**CHANGES FROM SCHEME PERMITTED
UNDER ABP-307415-20 BLOCK 3:**

**PROPOSED
GROUND FLOOR**

LISIEUX PARK

Project	6-7 HARDCOURT TERRACE, DUBLIN 2, IRELAND 11 363 1 618 2100 11 363 1 676 7385 architectural@bkd.ie www.bkd.ie
Drawing Title	RESIDENTIAL APARTMENTS, LISIEUX PARK Murphystown Road, leopoldstown, Dublin 18
Stage	Planning
Scale	1:200@A1
Drawn	MG
Apd	FF
Date	03.04.2023
Project Code	6275
job	LIS
origin	BKD
zone	00
level	00
type	DR
dis	A-
sheet no.	1100
status	P04
rev

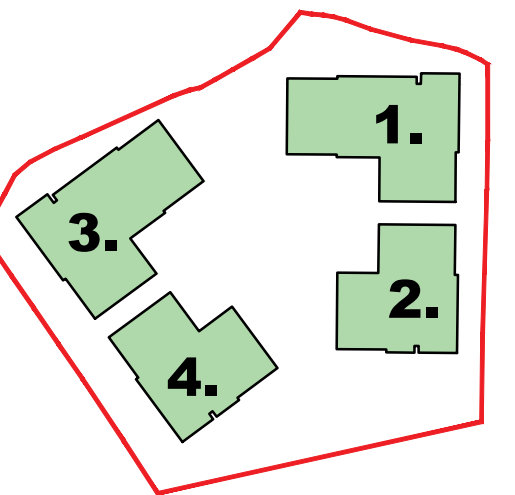
- GLAZED CORRIDOR LINK REMOVED FROM THE COURTYARD SIDE OF BLOCK 3.
- INCREASE IN FLOOR AREA TO CRECHE, NOW TAKING IN AREA CREATED BY OMISSION OF GLAZED CORRIDOR TO BLOCK 3
- RECONFIGURATION OF LIFT/STAIR CORES TO COMPLY WITH DAC / FSC REQUIREMENTS.
- EN-SUITES REMOVED FROM ALL 2 BED UNITS.
- ALL PERMITTED BEDROOM DOORS OPENING ON TO BALCONIES CHANGED TO WINDOWS TO IMPROVE SAFETY AND SECURITY.
- RECONFIGURED EXIT AND CORRIDOR TO THE COURTYARD FROM BLOCK 3.
- RECONFIGURED FIRE EXIT / FIRE FIGHTING ENTRANCE TO CORE 4, NOW FROM KILGOBBIN ROAD TO COMPLY WITH FIRE SAFETY CERT REQUIREMENTS.
- UNIT 14 CONVERTED FROM 2 BED TO A 1 BED.
- UNIT 15 & 17 CONVERTED FROM A 1 BED TO A 2 BED.
- UNIT 16 APARTMENT LAYOUT REVISED AND CONVERTED FROM 2 BED (3 Person) TO 2 BED (4 Person).

- CURVED GLAZED RECEPTION AREA REMOVED
- GLAZED LINK BETWEEN BLOCKS 1 & 2 AND BLOCKS 3 & 4 REMOVED
- ADJUSTMENTS TO PERMITTED LANDSCAPE DESIGN TO ALIGN WITH OMISSION OF COVERED WALKWAYS AND RECEPTION AREA.

- GLAZED CORRIDOR LINK REMOVED FROM THE COURTYARD SIDE OF BLOCK 4.
- RECONFIGURATION OF LIFT/STAIR CORES TO COMPLY WITH DAC / FSC REQUIREMENTS.
- EN-SUITES REMOVED FROM ALL 2 BED UNITS.
- ALL PERMITTED BEDROOM DOORS OPENING ON TO BALCONIES CHANGED TO WINDOWS TO IMPROVE SAFETY AND SECURITY.
- RECONFIGURED FIRE EXIT / FIRE FIGHTING ENTRANCE TO CORE 4, NOW FROM KILGOBBIN ROAD TO COMPLY WITH FIRE SAFETY CERT REQUIREMENTS.
- UNIT 18 & 20 CONVERTED FROM A 1 BED TO A 2 BED.
- UNIT 19 APARTMENT LAYOUT REVISED AND CONVERTED FROM 2 BED (3 Person) TO 2 BED (4 Person).
- UNIT 21 CONVERTED FROM A 2 BED TO A 1 BED

- GYM FOOTPRINT AMENDED TO ALIGN WITH WALLS OVERHEAD.
- NEW SEPARATE ENTRANCE TO GYMNASIUM ADDED
- RECONFIGURED ENTRANCE TO BLOCK 1 FROM COURTYARD.
- GLAZED LINK CORRIDOR REMOVED FROM THE COURTYARD SIDE OF BLOCK 1.
- RECONFIGURATION OF LIFT/STAIR CORES TO COMPLY WITH DAC / FSC REQUIREMENTS.
- EN-SUITES REMOVED FROM ALL 2 BED UNITS.
- ALL PERMITTED BEDROOM DOORS OPENING ON TO BALCONIES CHANGED TO WINDOWS TO IMPROVE SAFETY AND SECURITY.
- RECONFIGURED FIRE EXIT / FIRE FIGHTING ENTRANCE TO CORE 1, NOW FROM MURPHYSTOWN WAY TO COMPLY WITH FIRE SAFETY CERT REQUIREMENTS.
- UNIT 2 CONVERTED FROM A 2 BED TO A STUDIO.
- UNIT 3 CONVERTED FROM A 1 BED TO A 2 BED.
- UNIT 4 APARTMENT LAYOUT REVISED AND CONVERTED FROM 2 BED (3 Person) TO 2 BED (4 Person).
- UNIT 5 CONVERTED FROM A 1 BED TO A 2 BED.

- GLAZED CORRIDOR LINK REMOVED FROM THE COURTYARD SIDE OF BLOCK 2.
- RECONFIGURATION OF LIFT/STAIR CORES TO COMPLY WITH DAC / FSC REQUIREMENTS.
- EN-SUITES REMOVED FROM ALL 2 BED UNITS.
- ALL PERMITTED BEDROOM DOORS OPENING ON TO BALCONIES CHANGED TO WINDOWS TO IMPROVE SAFETY AND SECURITY.
- RECONFIGURED ENTRANCE FROM THE COURTYARD TO BLOCK 2.
- RECONFIGURED FIRE EXIT / FIRE FIGHTING ENTRANCE TO CORE 2, NOW FROM MURPHYSTOWN WAY TO COMPLY WITH FIRE SAFETY CERT REQUIREMENTS.
- UNIT 6 CONVERTED FROM A 1 BED TO A 2 BED.
- UNIT 7 APARTMENT LAYOUT REVISED AND CONVERTED FROM 2 BED (3 Person) TO 2 BED (4 Person).
- UNIT 8 CONVERTED TO FROM A 1 BED TO A 2 BED
- UNIT 9 CONVERTED FROM A 2 BED TO A 1 BED
